MEMORANDUM

SUBJECT: Item No. 5.1 – DA2023/1775 13 Quinton Road, Manly

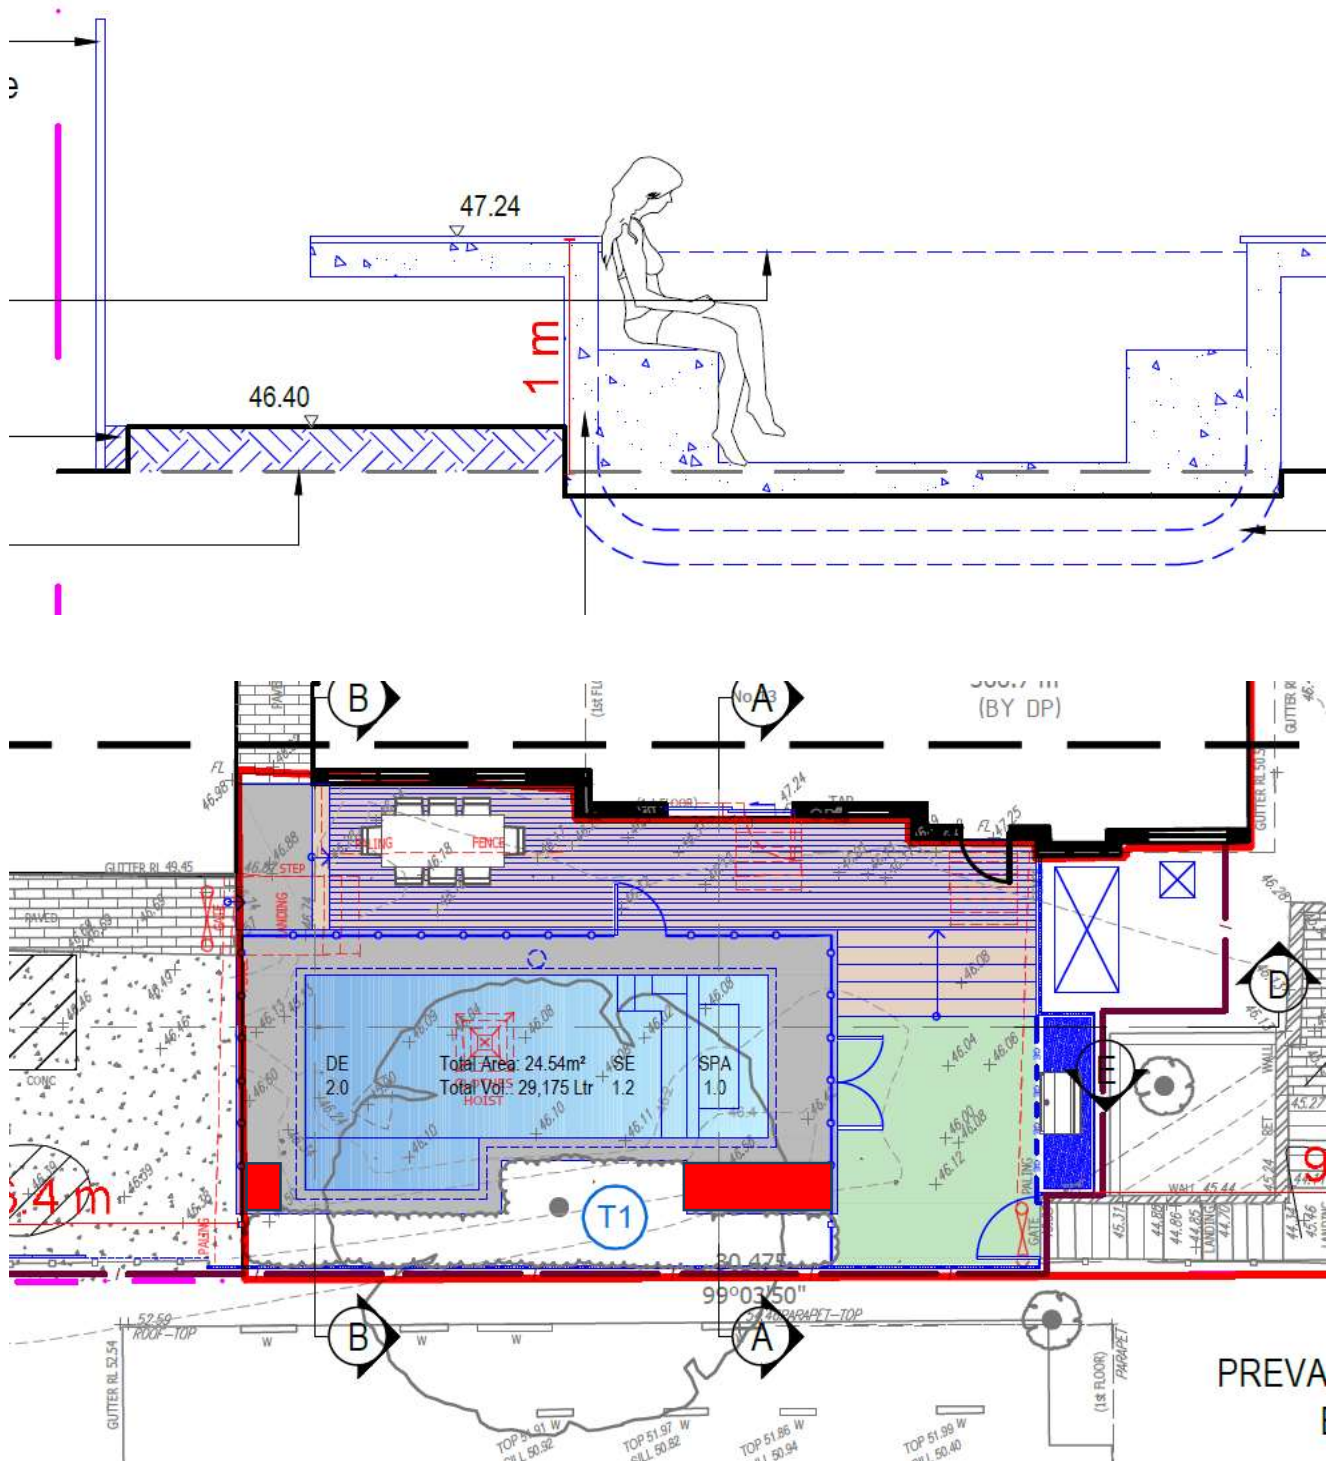
However, it is the elevated paved concourse close to the boundary that is of concern, effectively reducing the fence height to 800mm when standing on the pool concourse as can be seen in the below section. It is proposed that the concourse of the pool should be amended to increase the setback of these areas from the boundary. These areas are marked in red on the plan below and should be maintained at ground level.

The arguments that persons within the pool are considered reasonable, however no elevated pool concourse should be within 2.1 metres of the boundary with the exception of pool coping with a max width of 400mm.

- The pool concourse is to maintain a minimum 2.1 metre setback to the southern side boundary. Only the pool coping (of a maximum width of 400mm) is to be within 2.1 metres of the southern side boundary.
- Landscape screen planting capable of achieving a height of 2.5m is to be provided to the southern side boundary adjoining the spa and concourse. Selected planting shall comply with the requirements of Australian Standard AS 1926.1 for a Non Climbable Zone.
